Re: Turkey Point Units 3 and 4  
Docket Nos. 50-250 and 50-251  
Response to NRC Request for Additional Information (RAI) Regarding  
Extended Power Uprate (EPU) License Amendment Request (LAR) No. 205  
and Mechanical/Civil Engineering Issues

RESPONSE TO NRC RAI REGARDING EPU LAR NO. 205  
AND EMCB MECHANICAL/CIVIL ISSUES

Figure 1 - Conceptual Design of Feedwater Heater Outlet Nozzle HELB Deflector Shield

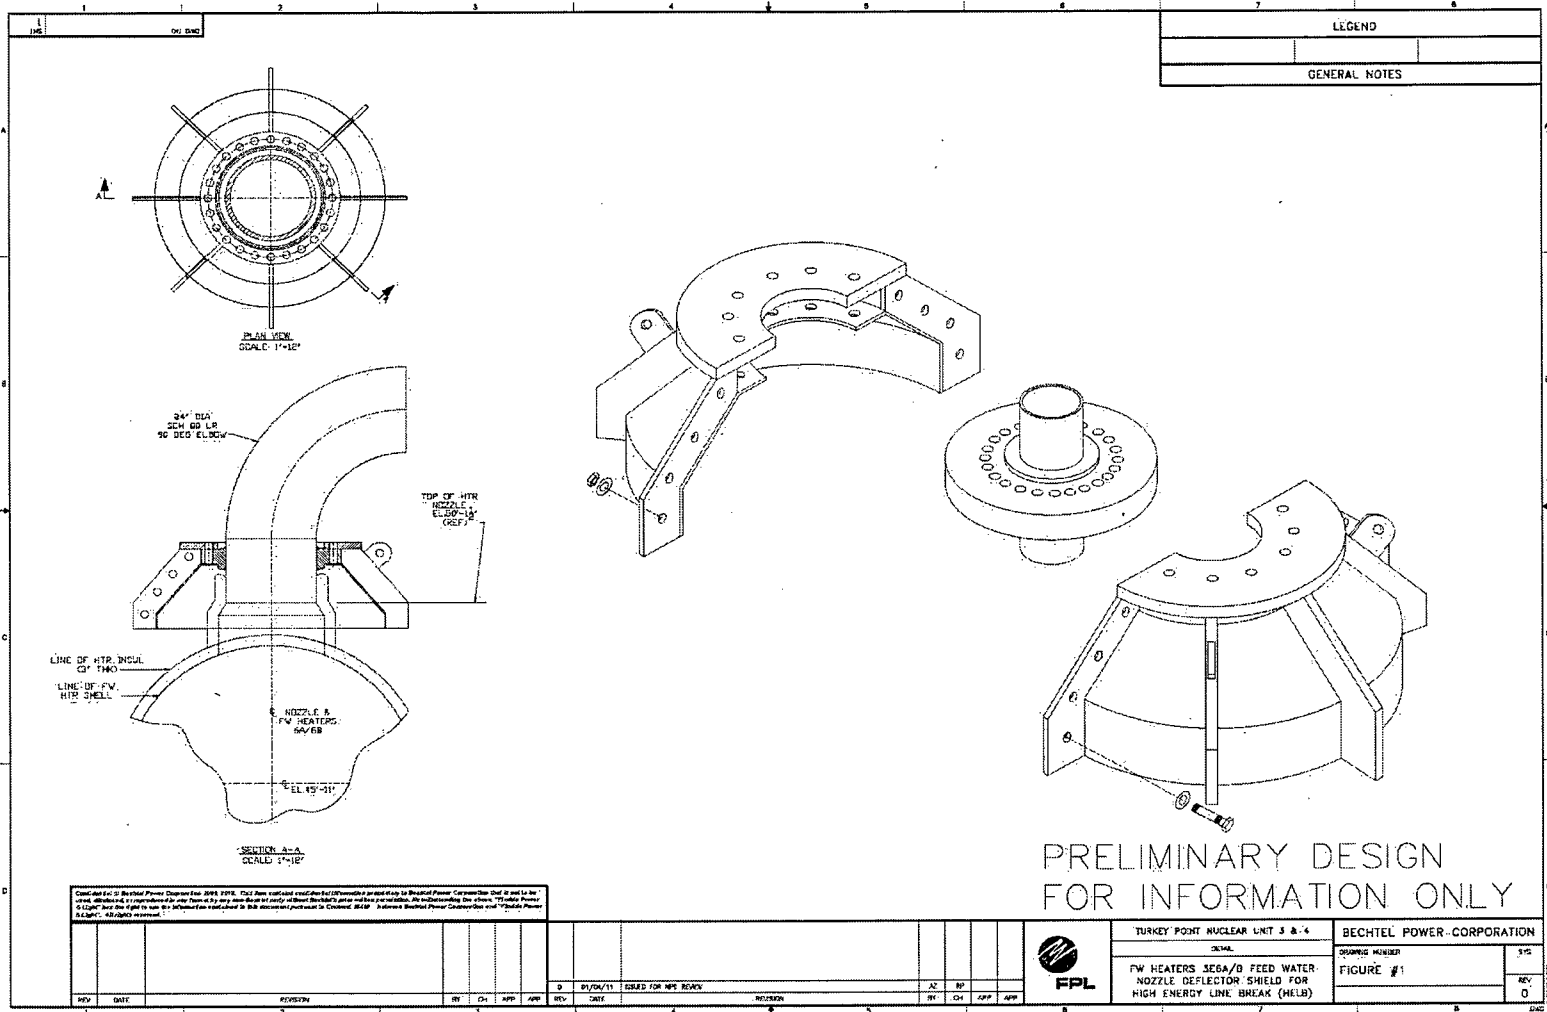
3. **In Section 2.5.1.3.2.3.4 (Attachment 4, Licensing Report) the licensee notes the replacement of the 6<sup>th</sup> feedwater heaters will result in resizing of the discharge piping from 18 inches to 24 inches. The jet impingement zones of influence are increasing due to EPU requiring modifications to shield equipment important to safety. These statements indicate that the evaluations (design and analysis) of 24 inch discharge piping, and shield equipment required to support the EPU have not been performed yet. Therefore, the licensee has not provided sufficient technical information for staff's review to determine whether reasonable assurance exists to conclude that the integrity of the required modifications are structurally adequate for the proposed EPU.**

Two of the terminal end break locations for the main feedwater piping are at the outlet of the Units 3 and 4 E6A/B feedwater heaters. Due to increase of the feedwater heater outlet nozzle diameter to 24" from the current outlet nozzle diameter dimension of 18", there is an associated increase in the size of the pipe break zone of influence. The calculated zone of influence for EPU conditions is 18' for the postulated break (increased from 13.5'). The impact to components important to safety from the increased jet impingement zone of influence has been evaluated in the PTN design change process for the replacement of the number 5 & 6 feedwater heaters in Units 3 and 4. Walkdowns encompassing an 18 foot zone of influence around each unit's number 6 feedwater heater outlet pipe have been performed to identify equipment important to safety. No equipment important to safety exists within the zone of influence of a circumferential main feedwater pipe rupture at the outlet nozzle terminal end. Safety-related pressure transmitters PT-3/4-486, PT-3/4-464, and PT-3/4-476 were identified to fall within or just outside the zone of influence of a longitudinal main feedwater pipe rupture at the outlet nozzle terminal end in both Unit 3 and Unit 4. These components are located within the main steam valve platform trestle area.

To protect these components new deflector shields will be installed on the feedwater outlet piping at the postulated longitudinal break locations at the number 6 feedwater heaters outlet nozzles. The shields are designed to redirect jet forces and guide stream loads in a direction away from the safety related equipment. The deflector shield is in a final design phase and will be evaluated further in the PTN design change process upon completion of the design. The preliminary configuration proposed for the HELB Deflector shield is shown in Figure 1.

The design and analytical details for the HELB deflector shield for PTN Units 3 and 4 are not yet finalized but, when complete, will be incorporated into each unit's main feedwater system modification package. The deflector shields will be designed as Class III Structures, Systems, and Equipment (SSE) but using the same design allowable stresses as those used for Class I SSEs defined in Appendix 5A of the PTN Updated Final Safety Analysis Report (UFSAR). Accordingly, as discussed with the NRC, FPL provides the following commitment with regard to the design and analyses of the HELB deflector shields that are planned to be
